802.1Qbg VSI Discovery and Configuration State Machine

V12

August 17, 2010

Expressing Bridge Resourcing States

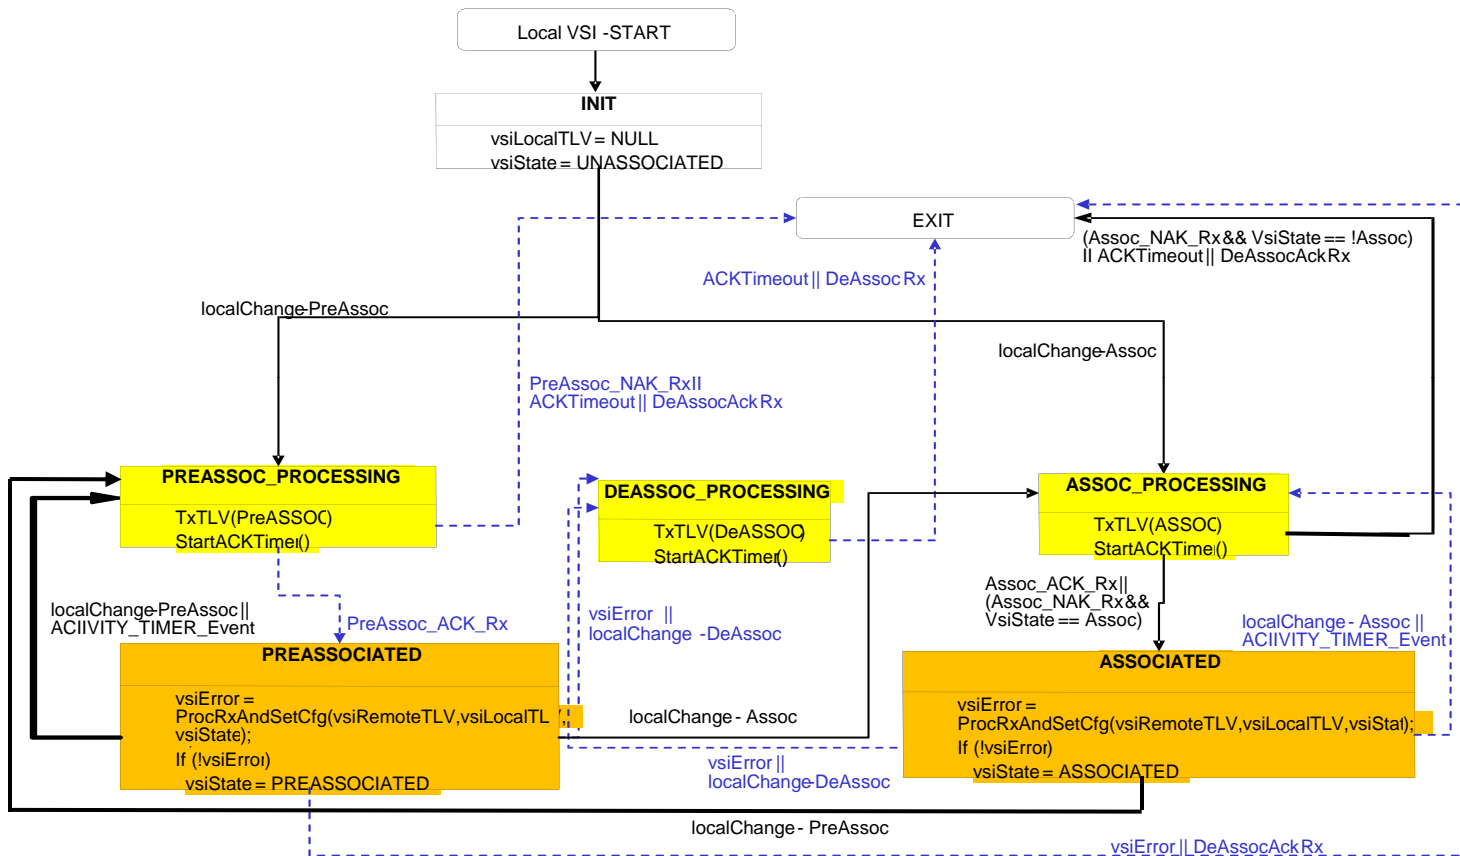
- Current state machine expresses the Bridge side resourcing request as a procedure hand-off.
- The bridge state machine hands the command to another machine which may query network management system before sending a response.
- It is convenient to break the command request into two states to allow time-out for the command hand-off
 - Need a timeout for the resource request from the Bridge
 - Need to build the response for the station from the resource request response
